Addendum No.: 1

Bid#: 21-19-2

Project Name: 2021 District 1, 4, 5, 10 Road Improvements

Bayberry Dr Specifications Revised

Bayberry Dr Field Notes Revised

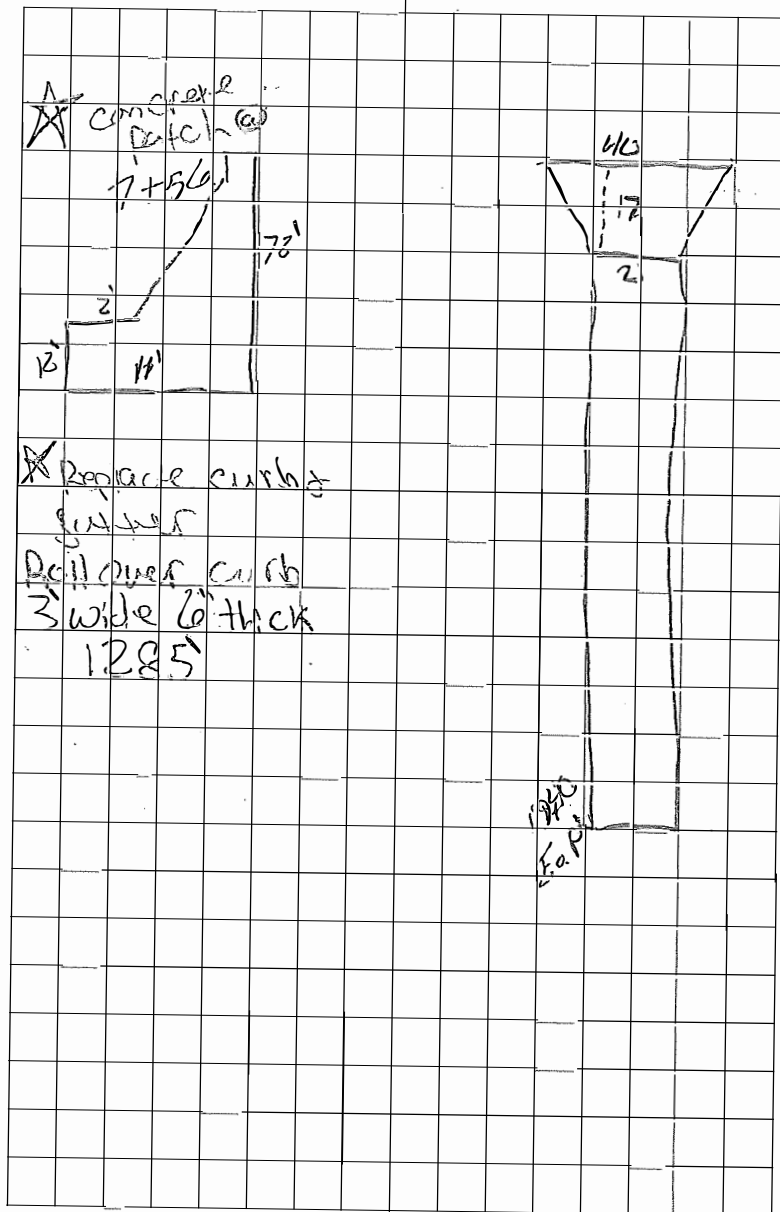
1. At Section 03 - Specifications – **DELETE** - Bayberry Dr. – **ADD** – Specifications- Bayberry Dr. REVISED(Attached)
2. At Section 03 – Field Notes – **DELETE** – Bayberry Dr. – **ADD** – Bayberry Dr. Field notes REVISED(Attached)
3. At Section 04- Unit Price Form – **Delete** - Unit Price Form – **ADD** –Unit Price Form REVISED (Attached)
The following Bid Items have been changed:
 - Ref No.: 306-01-00200 REMOVED
 - Ref No.: 303-01-00150 REMOVED
 - Ref No.: 501-01-00000 REMOVED
 - Ref No.: 501-01-00001 REMOVED
 - Ref No.: 502-01-00000-A Quantity from 25,551 to 30,038 SY
 - Ref No.: 509-01-00100 Quantity from 25,551 to 30,038 SY
 - Ref No.: 510-01-00200 Quantity from 1,977 to 2,377 SY
4. At Section 10 – Core Results – **DELETE** – Asphalt Core Test Results – **ADD** – Asphalt Core Test Results REVISED(Attached)

0+00 - Begins @ N. wedge of Laurelwood
going N.W.
man whole cover

0+05 - man whole cover

0+19 - R_E catch basin

1+00 - Road width - 21' with curb
in gutter.

4+21 - Catch basin L & R_E

2+85 - man whole cover R_E

6+00 - Road width 21'

7+56 - Concrete patch Begins
R_E

8+27 - catch basin L & R_E concrete
patch between 3' wide 21' long

★ Replace curbs
gutter
Roll over curb
3' wide 6" thick
1285'

9+52 - man whole cover 9

10+00 - Road width 21'

11+94 - Catch basin 28 R S

15+46 - Catch basin 28 R S

18+78 - Cul-de-sac begins - Road
width - 21'

19+40 - E.O.P. End of asphalt
cul-de-sac - 44' wide
